CITY OF SAN ANTONIO
TRANSPORTATION & CAPITAL IMPROVEMENTS

ADDENDUM No. 2

PROJECT NAME: FIRE STATION # 2 REPLACEMENT, Project No. 20-00011

DATE: May 17, 2016

1 FLOOR PLAN
SCALE: 1/8" = 1'-0"

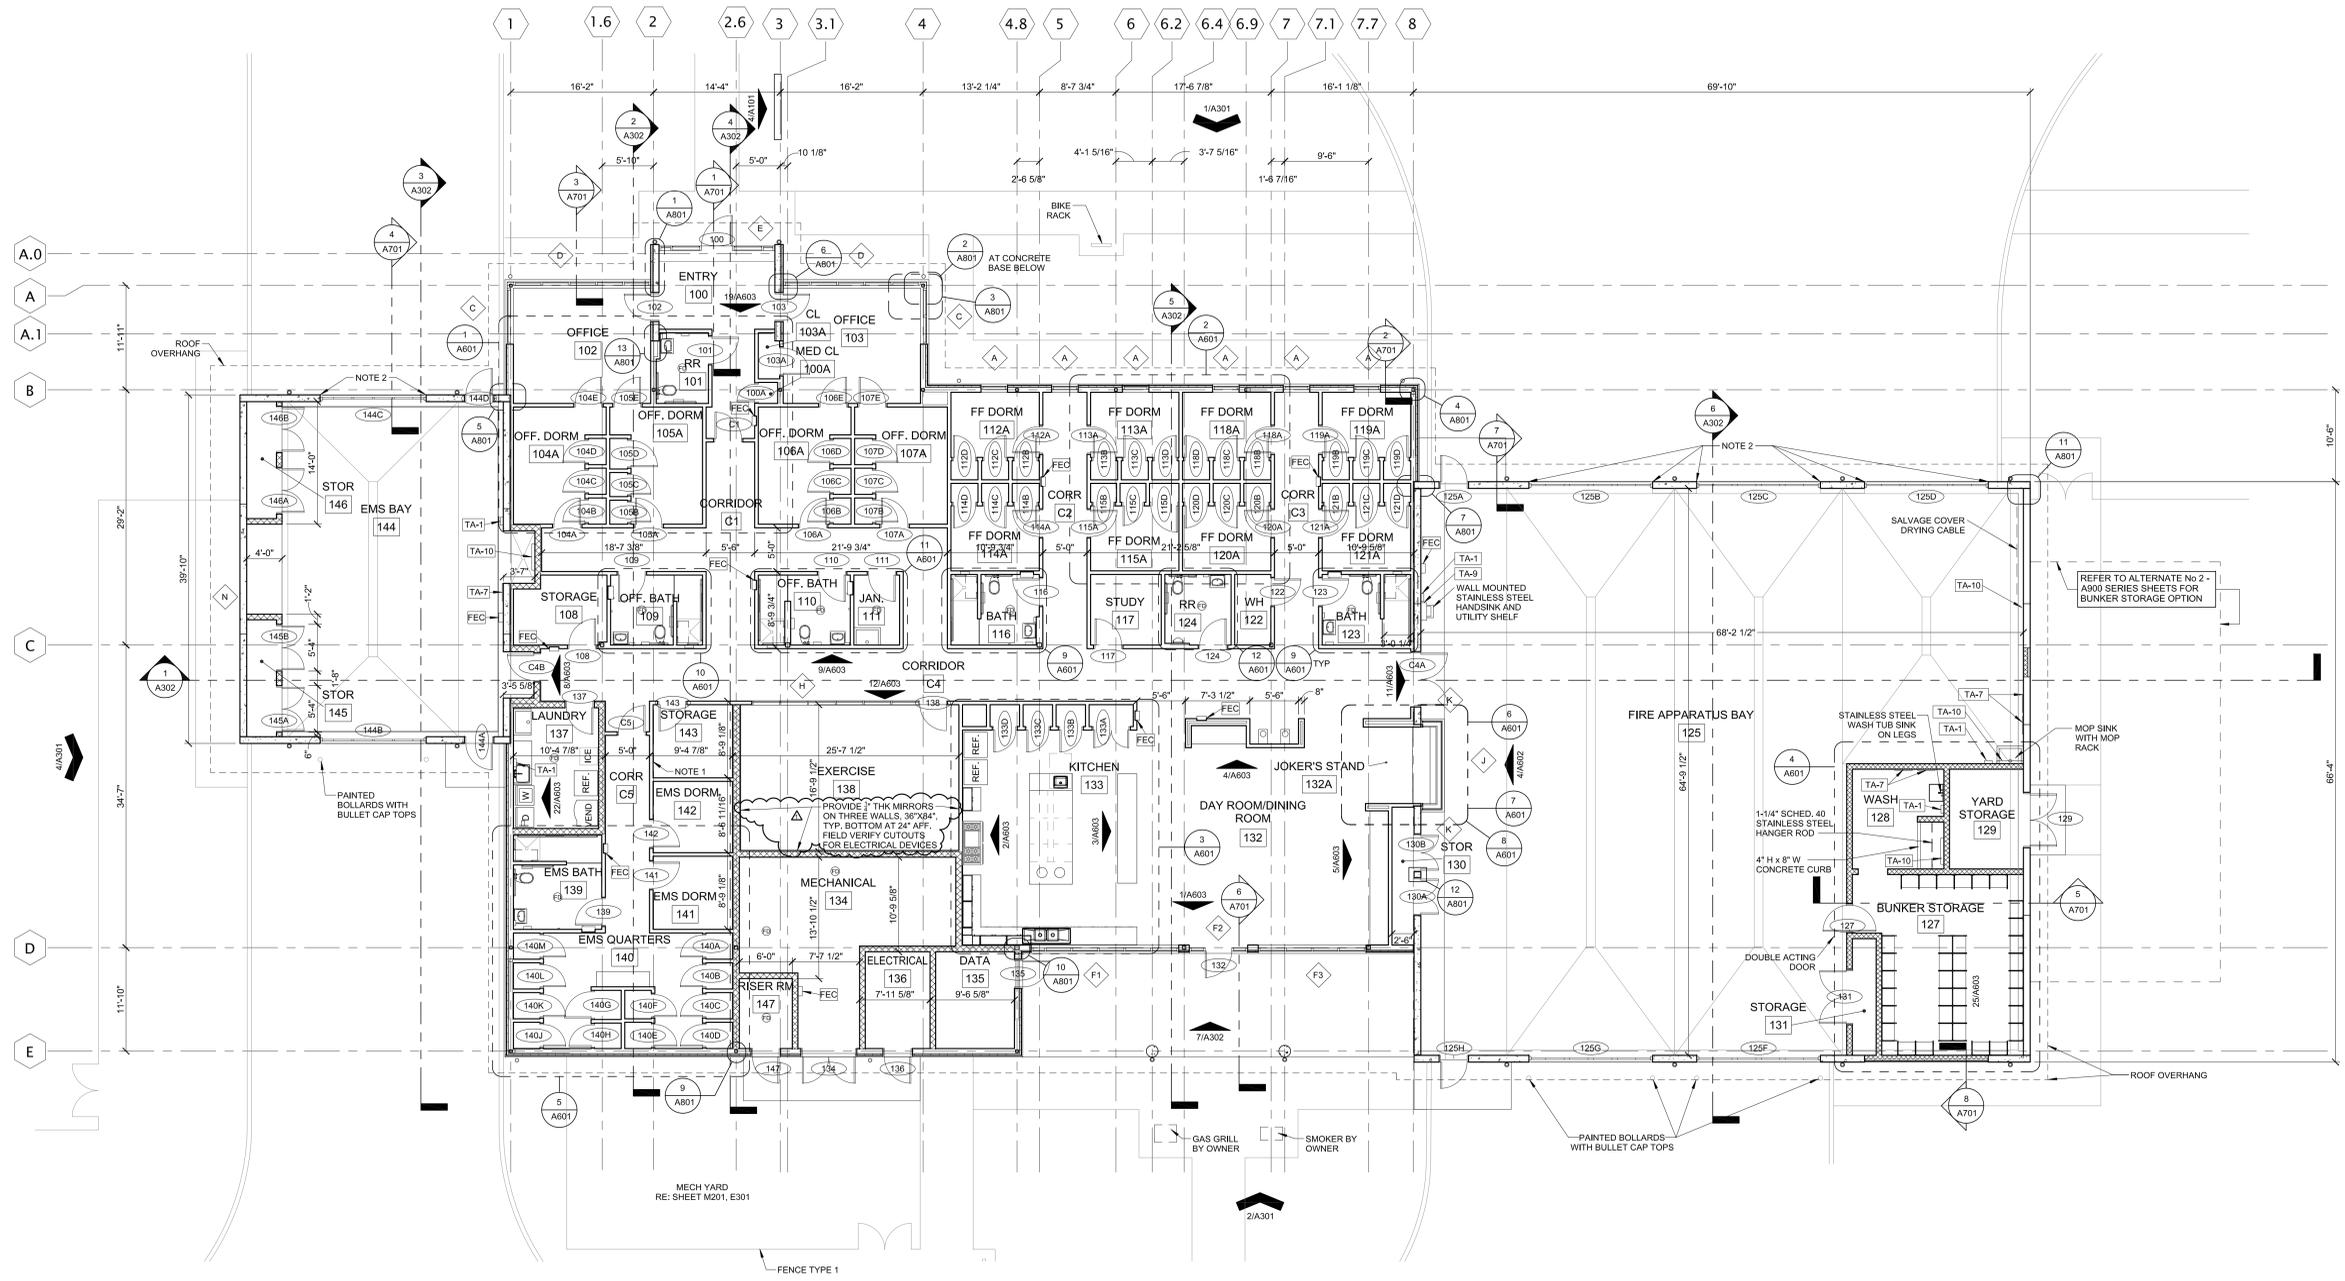
1. Replace Drawing Sheet A201
 - a. Add mirrors in EXERCISE 138.

M201

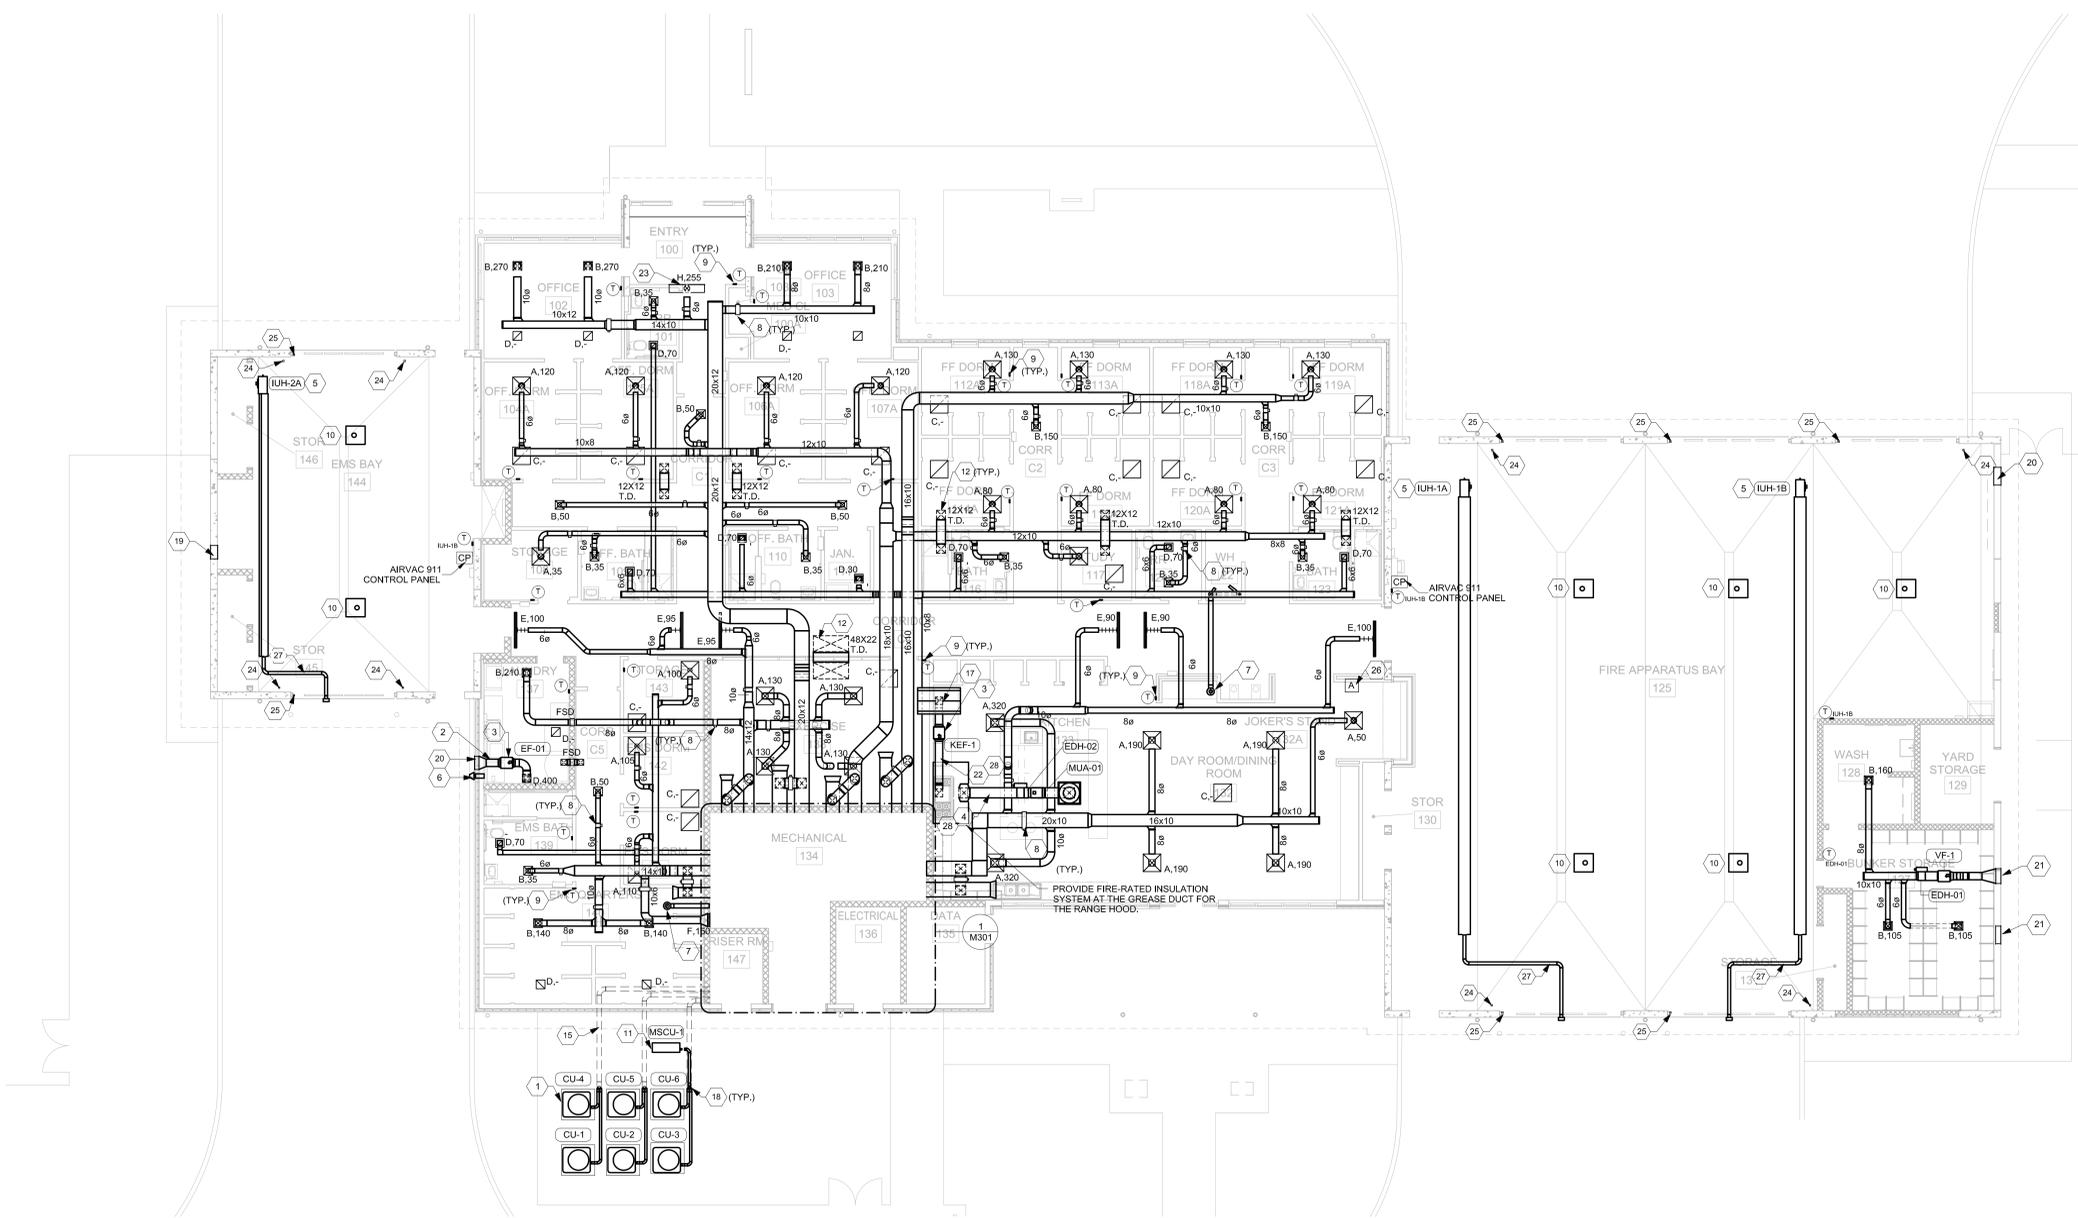
1. Replace Drawing Sheet M201
 - a Revised mechanical keyed note #10.
2. Replace Drawing Sheet M201A
 - b Revised mechanical keyed note #10.

10. PROVIDE AIRVAC 911 ENGINE EXHAUST REMOVAL SYSTEM. SUSPEND 18" BELOW STRUCTURE. LOCATE UNIT MINIMUM OF 24" FROM OBSTRUCTIONS. INSTALL PER MANUFACTURER'S REQUIREMENTS.

Sheet Number
E201

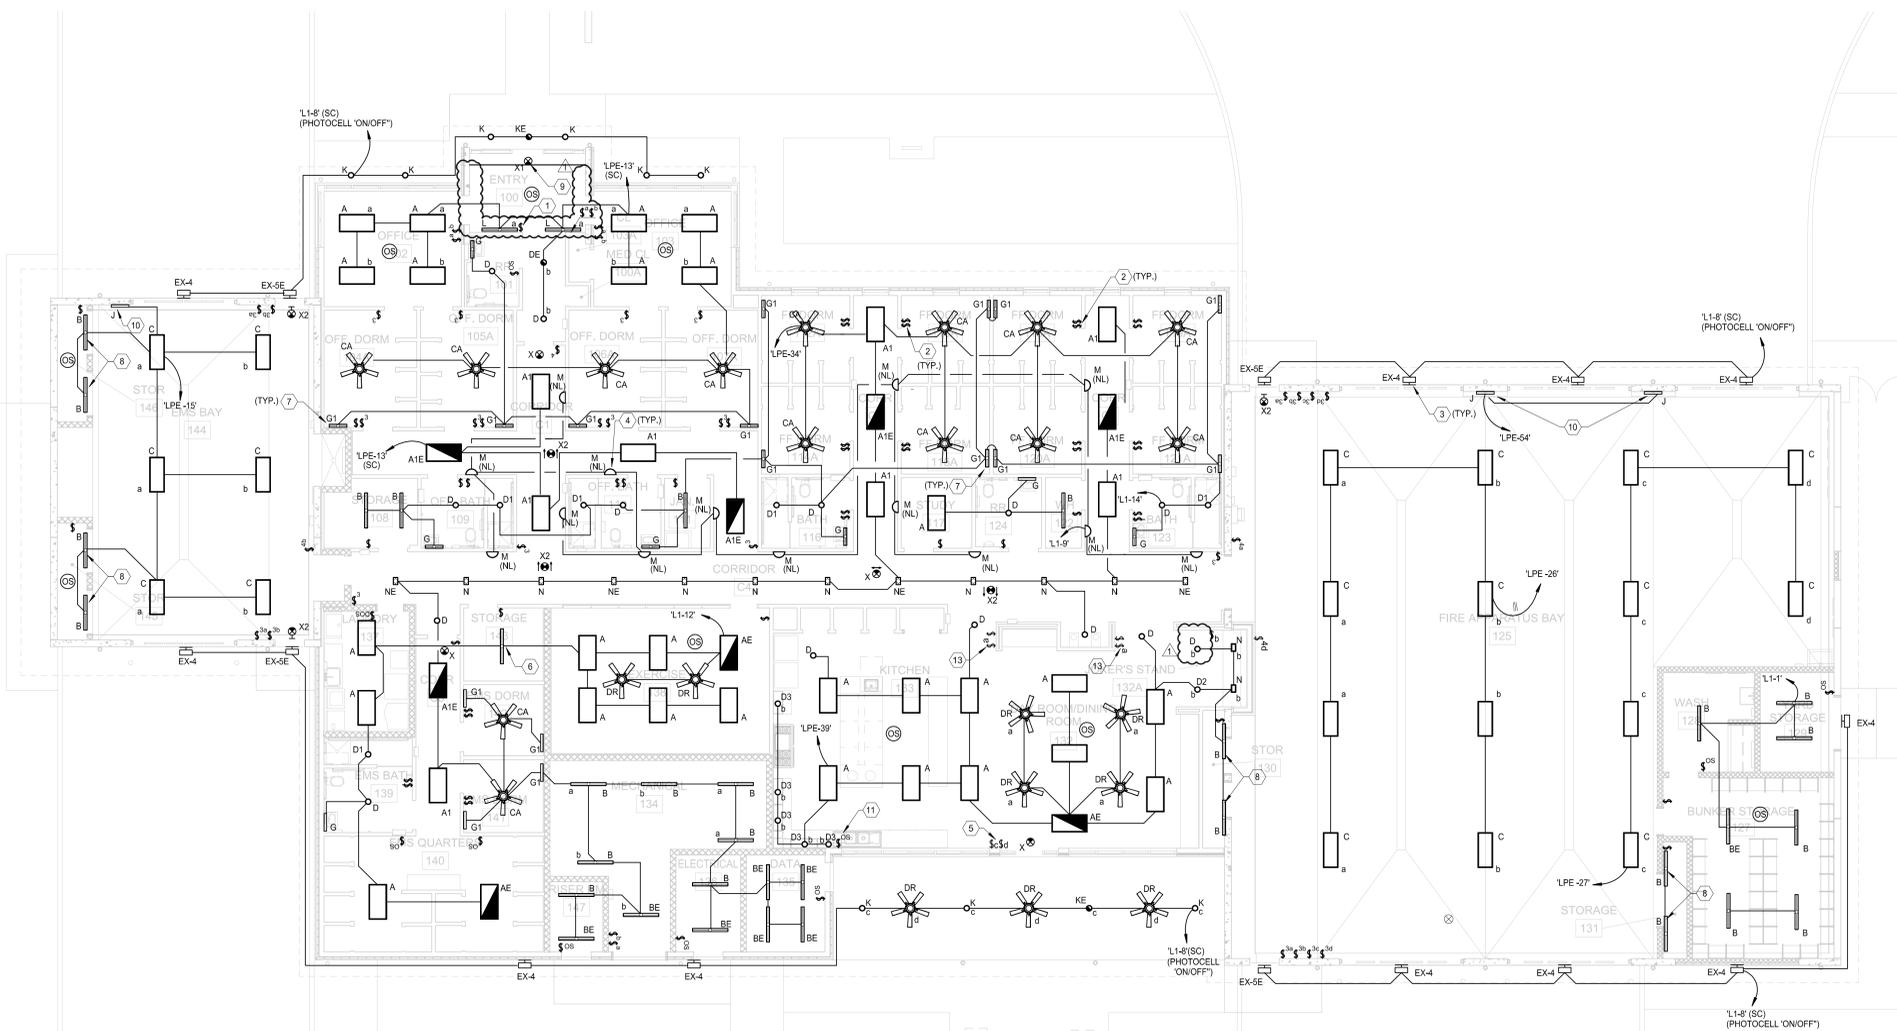
1. Replace Drawing Sheet E201A
 - a: Replaced the type 'D' with a type 'D2' wallwash type fixture.
 - b: Relocated the Type 'L' lighting fixtures in the Foyer.
2. Replace Drawing Sheet E201A
 - a. Replaced the type 'D' with a type 'D2' wallwash type fixture.
 - b. Relocated the Type 'L' lighting fixtures in the Foyer.
3. Replace Drawing Sheet E301
 - a. Modified key notes no. 5 and no. 18.

E501

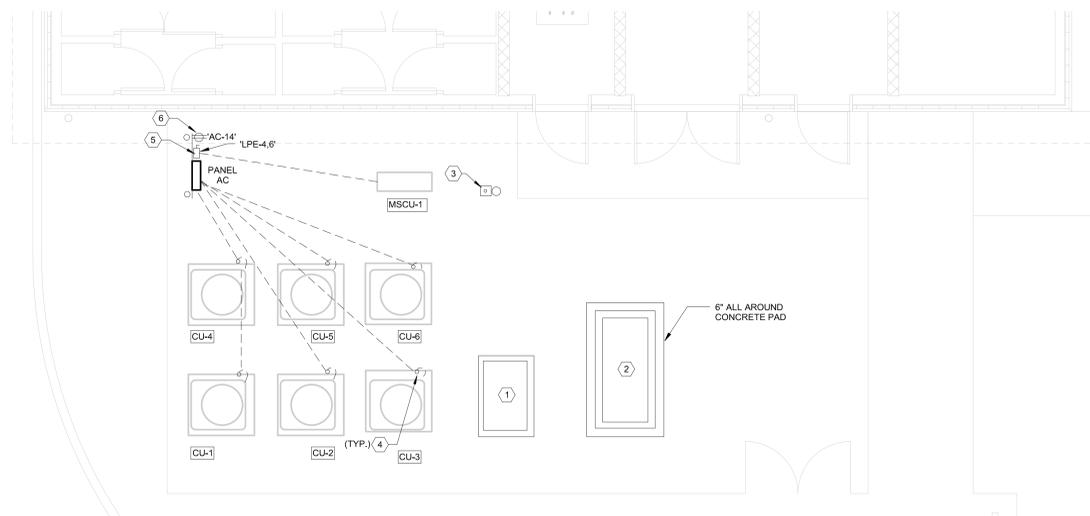
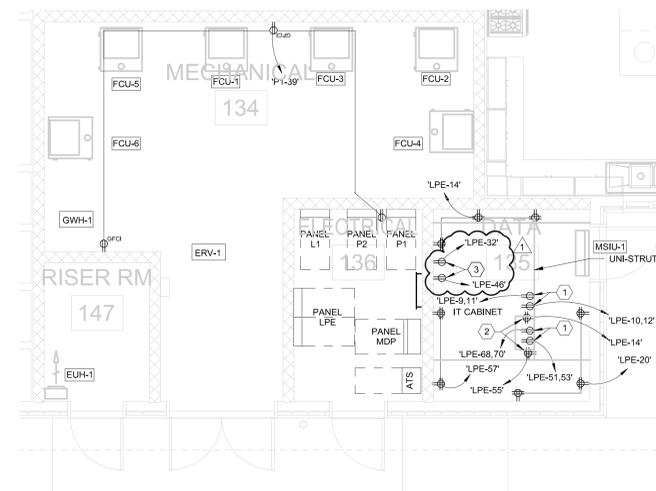
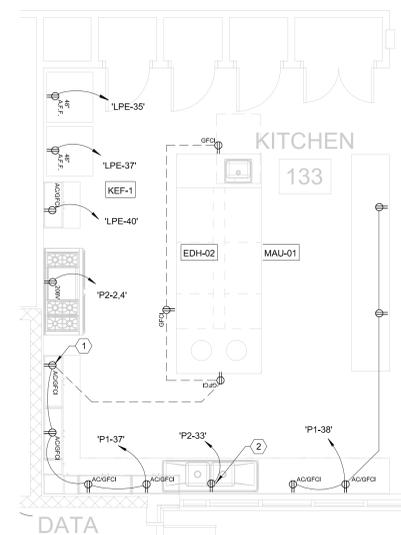
- a. Added two (2) dedicated receptacles for the Phoenix Alerting System.

1 FLOOR PLAN - IT
 1/8" = 1' - 0"

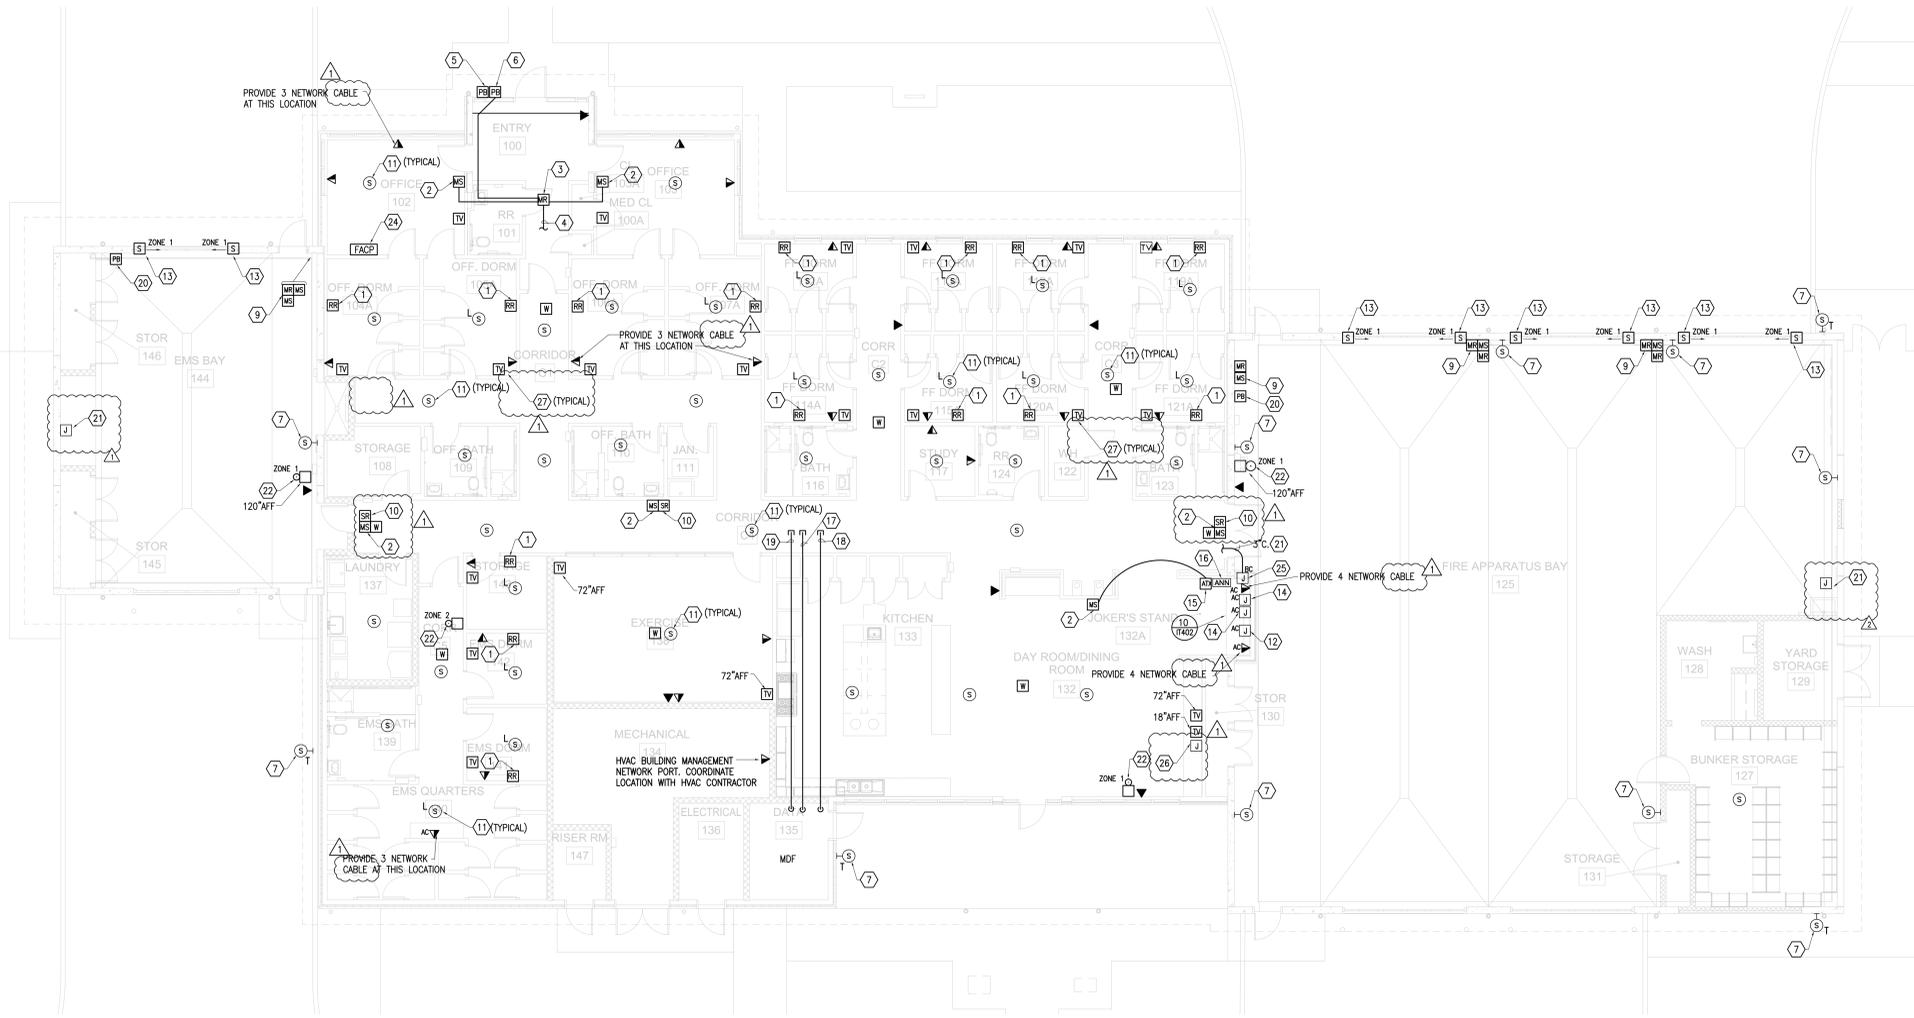
- a. Added keyed notes 26 and 27.
- b. Modified phone outlet description on legend to read as mounted at 48" aff.
- c. Added j-boxes to antenna locations in the east and west end of the bldg.
- d. Modified various notes for read as "cables" rather than "drops".
- e. Added a j-box in the dayroom for an av-in location.
- f. Relocated mud ring devices.
- g. Modified key note no. 9 to read as the sign mounted at 9'-0".
- h. Added key note to drawing for typical TV outlets as being 12" to 18" from wall.
